**RAI No.:** 47

**Question No.:** 13.03-2 (ETE-1)

**ETE-1: Estimated Population Growth**

**BELL BEND NUCLEAR POWER PLANT  
RESPONSE TO RAI No. 47  
BNP-2009-292      Docket No. 52-039**

**Figure 2-1. Assumed Evacuation Response**

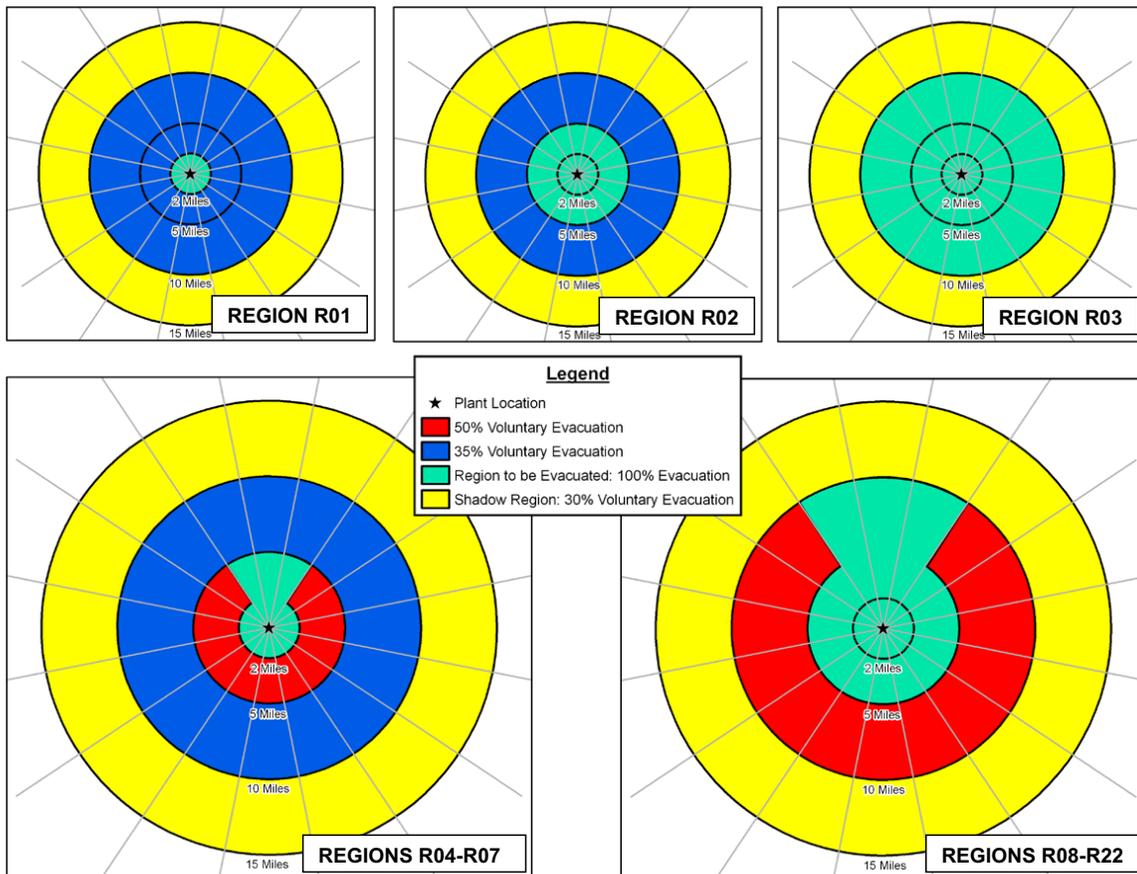
- A. Section 2, "Study Estimates and Assumptions," states that in Figure 2-1, "Assumed Evacuation Response," the area which is within the EPZ but outside the evacuation region (Regions R08-R22), will have a voluntary evacuation of 50 percent. Figure 2-1 (Regions R08-R22) shows a 35 percent voluntary evacuation rate for this area. Clarify whether the blue area depicting Regions R08-R22 in Figure 2-1 will have a 35 percent or 50 percent voluntary evacuation rate.

A. The text in assumption 4 of Section 2.2, "Study Methodological Assumptions" is correct, stating that 50 percent of the population within the EPZ but outside the evacuation region will elect to voluntarily evacuate. For consistency with the other figures, the text will be modified to indicate that this area is red, and Figure 2-1 will be modified so that the area in question will be shaded red instead of blue.

2. Figure 2-1 will be replaced with the attached figure in a future revision of the ETE Report.

Figure 1 – School Bus Evacuation Route

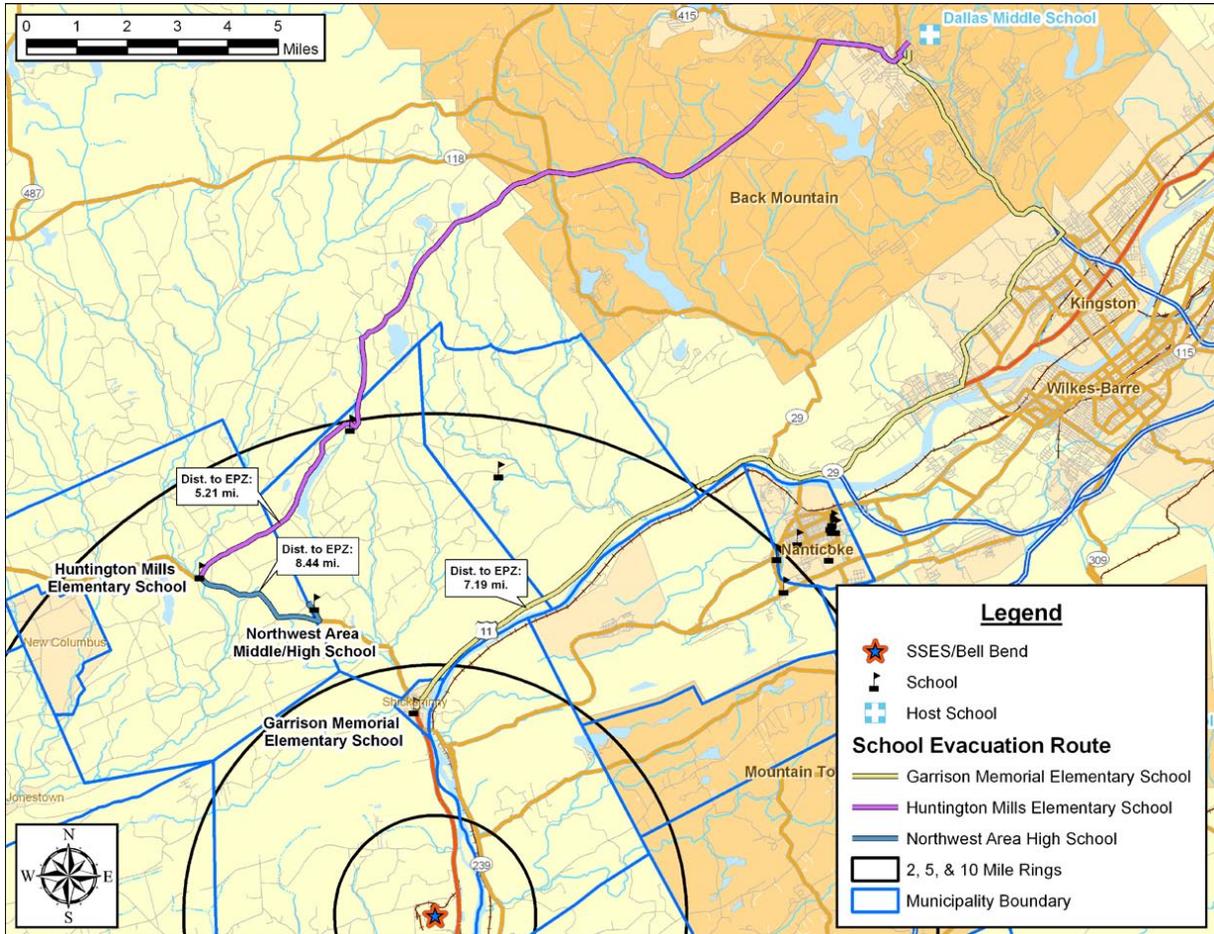
- A. Table 8-5A, "School Evacuation Time Estimates – Good Weather," indicates that the distances from Garrison Memorial Elementary School, Huntington Mills Elementary School and Northwest Area High School to the EPZ boundary is 11 miles. Discuss how traveling these distances through the EPZ reflects a generally radial evacuation, as recommended in NUREG 0654. Revise the ETE report as needed.

The attached Figure 1 shows the likely evacuation routes between the three cited schools and the host, Dallas Middle School. As presented in Figure 1, the lengths of the routes between these schools and the EPZ boundary are 7.2 mi, 8.4 mi and 5.2 mi. These routes which are generally outbound relative to the location of the nuclear power plant will be updated in a future revision of the ETE study, along with the ETE in Tables 8-5A and 8-5B.

1. Tables 8-5A and 8-5B will be updated in a future revision of the ETE Report with the updated evacuation route distances.
